Reference: 17/00900/FUL
Validated: Wed 14 Sep 2016
Address: 67 Orchard Avenue Croydon CR0 7NE
Proposal: Demolition of the existing building. Erection of a terrace of 3 three bedroom houses with accommodation in the roof-space and formation of vehicular accesses onto Orchard Avenue. Erection of a detached two-bedroom bungalow at the rear and formation of vehicular access onto Woodland Way. Provision of associated parking, cycle and refuse storage for the whole development.
Ward: Shirley
Consultation close: 2nd May 2017

Please accept this formal letter of objection to the proposal for demolition of existing building; erection of a terrace of 3, three bedroom houses with accommodation in the roof-space and formation of vehicular accesses onto Orchard Avenue. Erection of a detached two-bedroom bungalow at the rear and formation of vehicular access onto Woodland Way.

Fig 1 Whole Site Layout

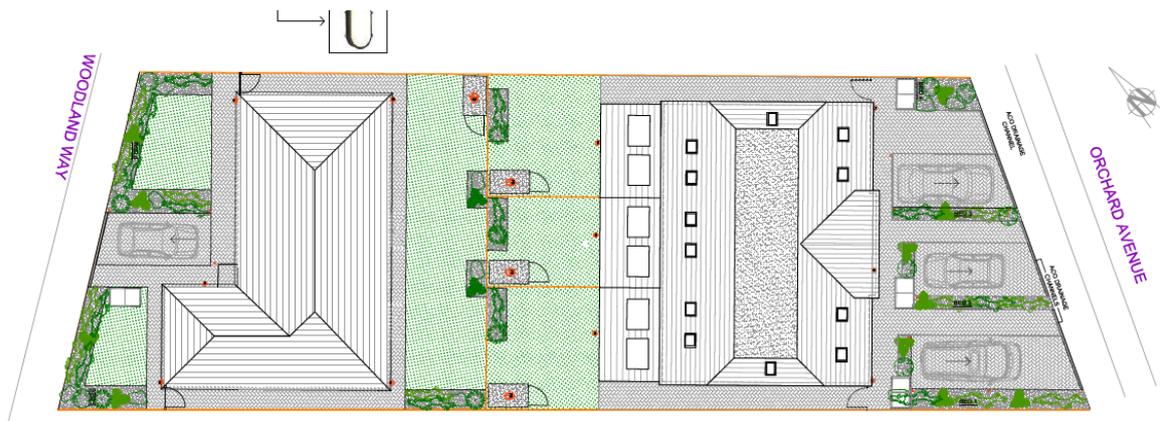
To provide a single parking space for each unit which requires either **entering in a forward gear and exiting in a reverse (or vice versa) into a busy Class C feeder road with no visibility splays** and high levels of **pedestrians and children** travelling en-route to local schools etc., is **unacceptable** in terms of **parking provision requirement** and is **exceedingly dangerous**. The whole site illustration (Fig 1) shows Unit 1 and Unit 3 vehicles had reversed into the parking space and Unit 2 vehicle entered the parking space in a forward direction. We understand these are only illustrations but it clearly shows there are **no visibility splays** to ensure the driver can clearly see whether it is **safe to exit from these parking spaces into a busy feeder road**, whether they originally drove into the parking space in a reversed direction or, even worse, if in a forward direction. **The parking provision is inadequate and dangerous.**

There have been major accidents at this very location in recent years [7] and the existing property allowed access and exit in a forward gear so there was minimum possibility of accidents as a result of exiting the site from the existing premises.

Similarly, for the Bungalow, access to parking on Woodland Way which also has **no visibility splays** for checking whether it is safe to exit from the parking space, if entered in a forward or reverse mode.

Residents of Unit 2 of the Terraced Block would need to **carry any Cycles through the house (via lounge and kitchen)** for access to the **Bike Store in the rear garden**. This is a very **unhygienic situation** as the tyres and wheels could have travelled through any number of disgusting mess.
